Please confirm the installation of 150 AMP. electrical
service entrance, located in same location of existing
overhead drop on Eastside of dwelling.
at the following address: 616 Haley Ave.

CITY OF NAPOLEON
ENGINEERING DEPARTMENT
APPLICATION FOR ELECTRICAL PERMIT
(PLEASE PRINT OR TYPE)

Owner's Name James Redd Address 616 Haley, Napoleon, Ohio

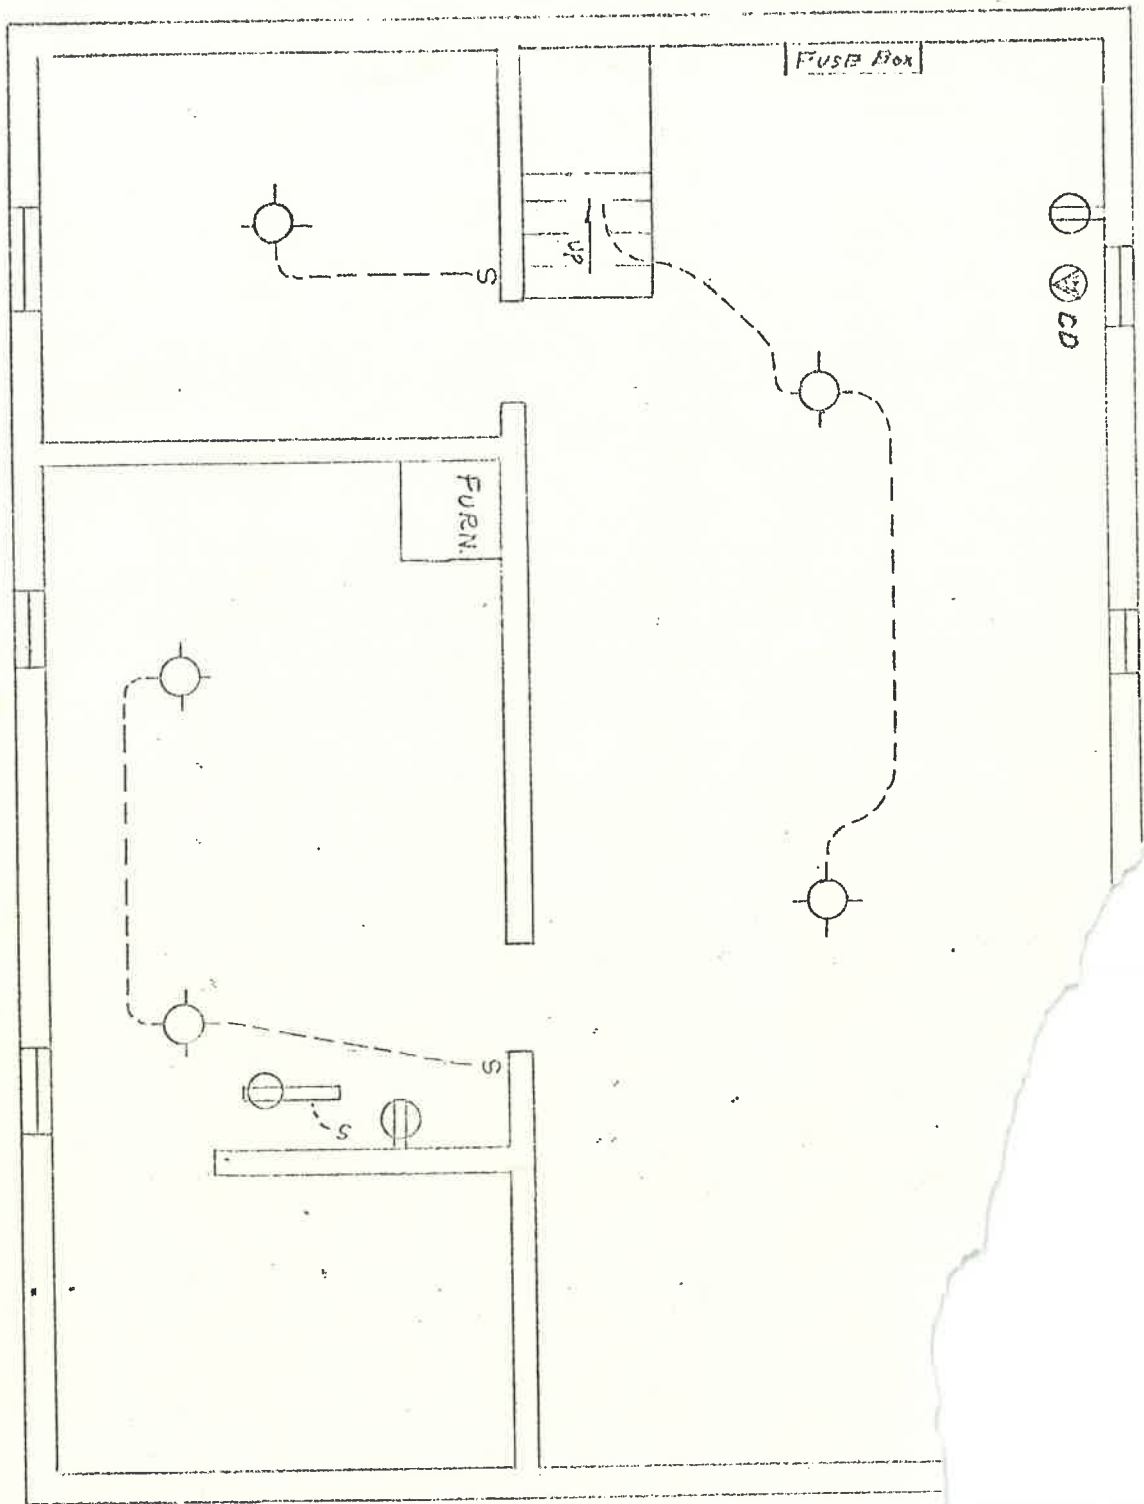
Remarks: Kun, owner doing his own work. He not familiar
with NEC, so please let me know if new service drop
will be located within 3' of any window or opening.
over

Severe about 4' from window - South Side

existing
East side now
